**MIDWEST  
GENERATION EME, LLC**

**IEPA ATTACHMENT NO. UU**

June 1, 2006

**Subject: Midwest Generation (MWGen) Comments on Lower Des Plaines River  
Temperature Criteria Options Report**

Figure 1:

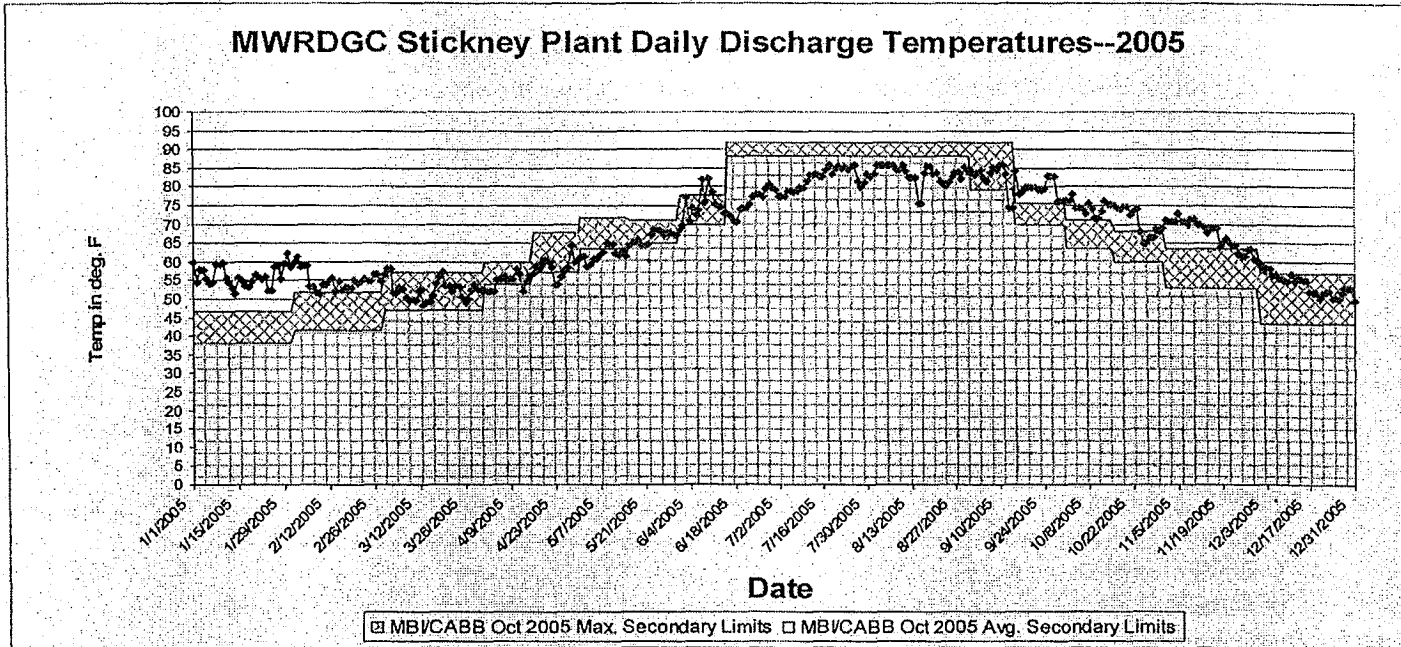
Data from the MWRDGC’s Stickney Plant discharge for 2005<sup>5</sup> show similar winter temperatures, as well as summertime values in excess of the proposed temperature limits, even for the MBI/CABB Secondary Contact option (see Figure 1, below) :

For the Lower Des Plaines River, the large contribution of treated wastewater from the Metropolitan Water Reclamation District of Greater Chicago (MWRDGC) Stickney Plant, making up over 90% of the upstream flow during non-summer months, largely controls the temperature regime of the system. (See Figure 2.6 of Holly and Bradley 1995 Report LD237). The effluent temperature from the MWRDGC discharge effectively serves to keep the waterway at a temperature which is, in effect, elevated from that which would be found in a “natural” system, especially during the non-summer period. Therefore, the water temperatures used as a basis for the seasonal analysis (*i.e.*, the Route 83 Cal-Sag site), are not representative of the conditions in the Chicago Sanitary and Ship Canal nor the Lower Des Plaines River (even without the addition of power plant discharges). The Lower Des Plaines River follows a different thermal regime, albeit still elevated, from that proposed by the 2005 MBI/CABB Report for both the summer and non-summer months.
